SUBJECT: AMENDMENT NO. 128 TO FACILITY OPERATING LICENSE NO. DPR-50  
(TAC 62065)

THREE MILE ISLAND NUCLEAR STATION, UNIT NO. 1

ATTACHMENT TO LICENSE AMENDMENT NO. 128

SUPPORTING AMENDMENT NO. 128 TO FACILITY OPERATING LICENSE NO. DPR-50

TMI-1 UNIT STAFF

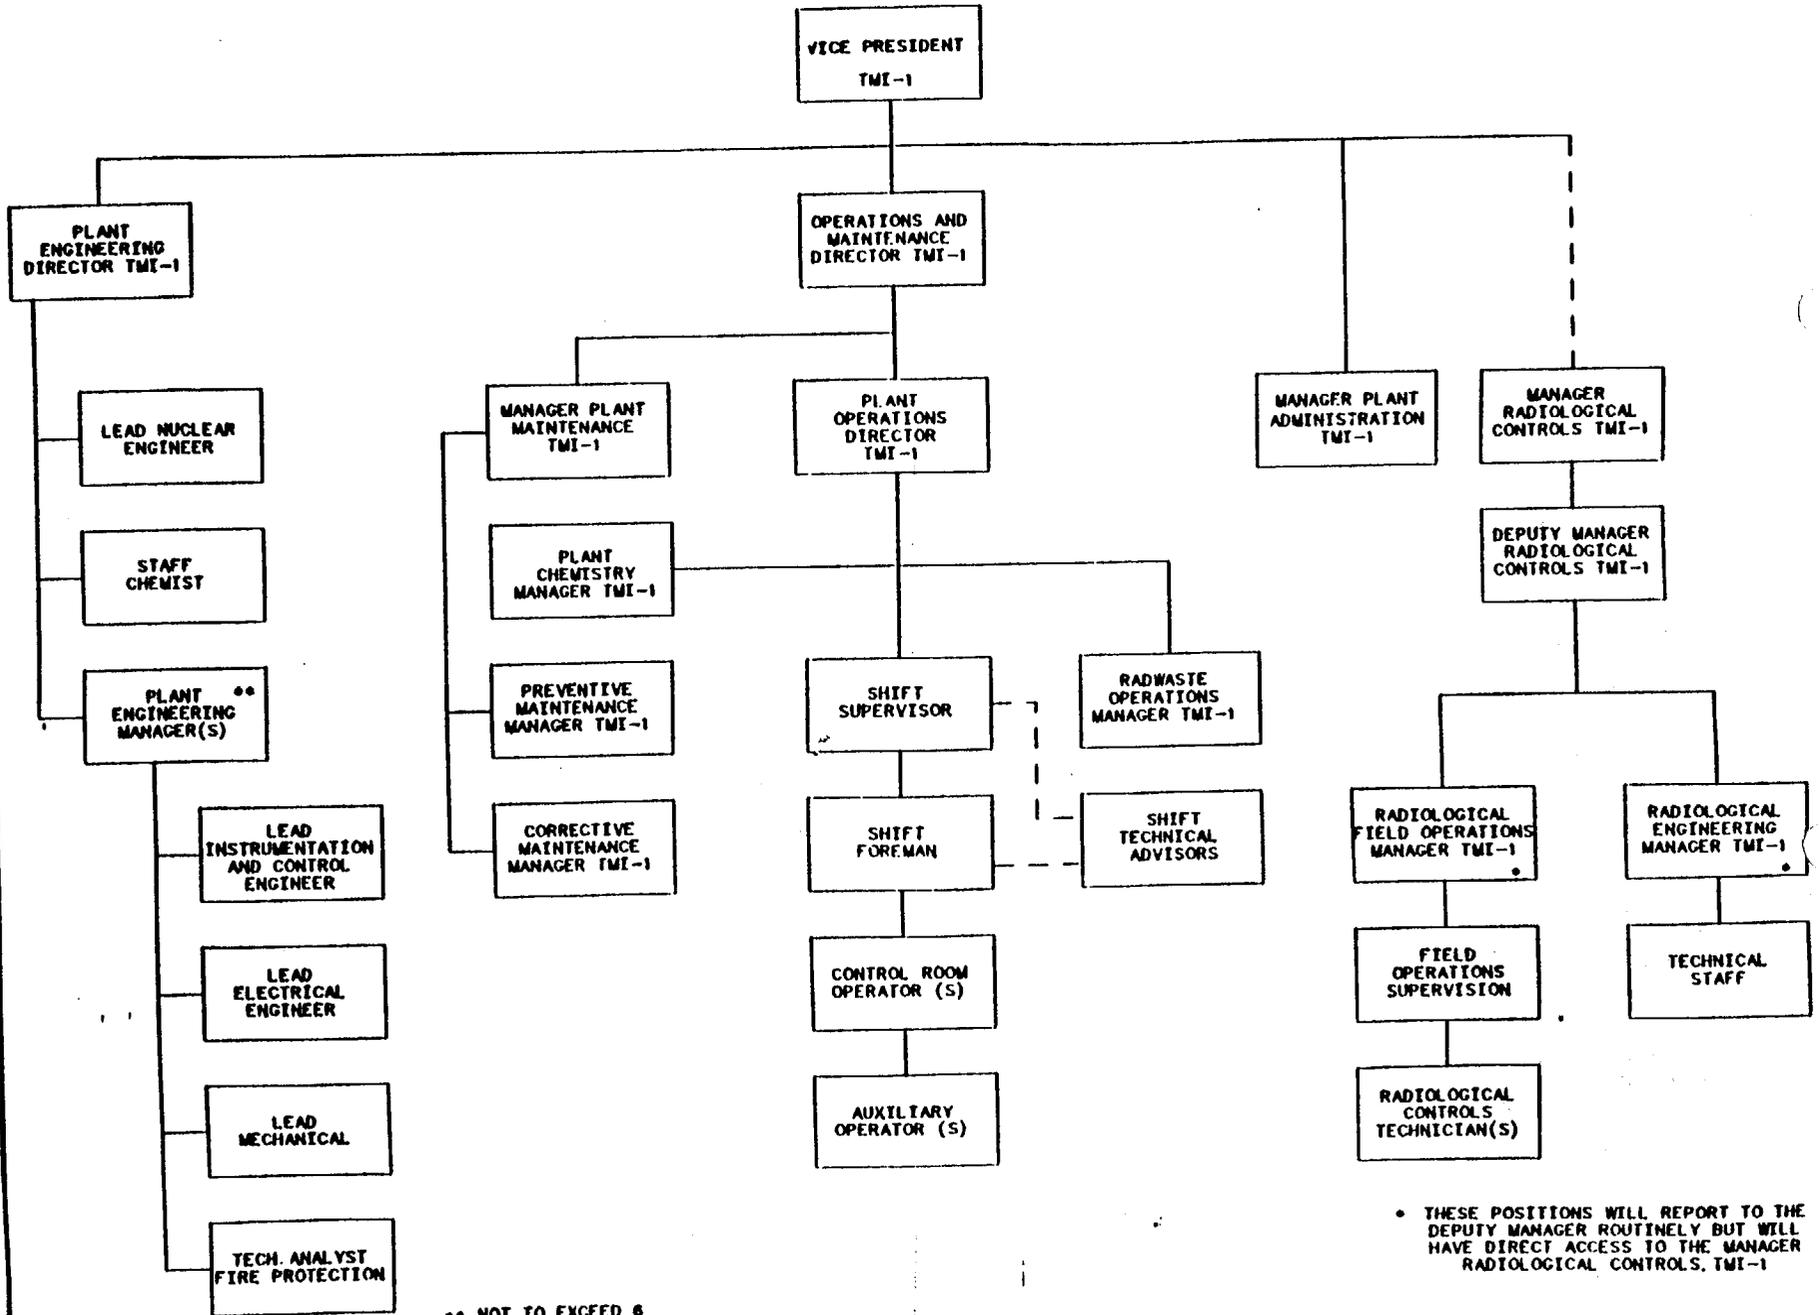
1. Position of training coordinator is deleted. This position was created to coordinate the development of training programs for the operations and maintenance departments. These training programs have been fully developed and implemented and the responsibility for continuation of the training programs will lie with the individual department managers and the training department. Therefore, the position of Training Coordinator is no longer required. This change does not result in any reduction in training requirements.

2. Title of the "Radiological Controls Foreman" in Figure 6-2 is changed to "Field Operations Supervision." This change is to make this position title at TMI-1 consistent with the corporate organizational philosophy of GPUN. Field Operations Supervision is a generic designation encompassing several levels of Radiological Controls management. The functional duties and qualifications of the Radiological Controls Supervisor will be consistent with those of the Radiological Controls Foreman.

3. References to "Type of License (RO or SRO)" are deleted from the Shift Supervisor, Shift Foreman and Control Room Operator boxes on Figure 6.2. This change is intended to remove some confusion which has existed; it makes no change to the license requirements for these positions. Technical Specification 6.2.2(a), Table 6.2.1, and Technical Specification 6.2.2(d) still identify the minimum shift crew composition and types of licenses to be held by these individuals.

4. Title of "Manager, Plant Operations TMI-1" is changed to "Plant Operation Director, TMI-1." This is to reflect the additional responsibilities of this office, and the particular individual's promotion within the company.

5. Plant Chemistry Manager, TMI-1 is placed under the authority of the Plant Operations Director, TMI-1. This change reflects completion of Plant Chemistry Department upgrades. With return to operation of TMI-1, this department is being placed under control of the Plant Operations Director, TMI-1.

The staff has evaluated the proposed changes to the Technical Specifications and concludes for the reasons stated above that these changes are administrative in nature and do not alter the functional duties of the TMI-1 unit staff. Therefore, these changes are acceptable.
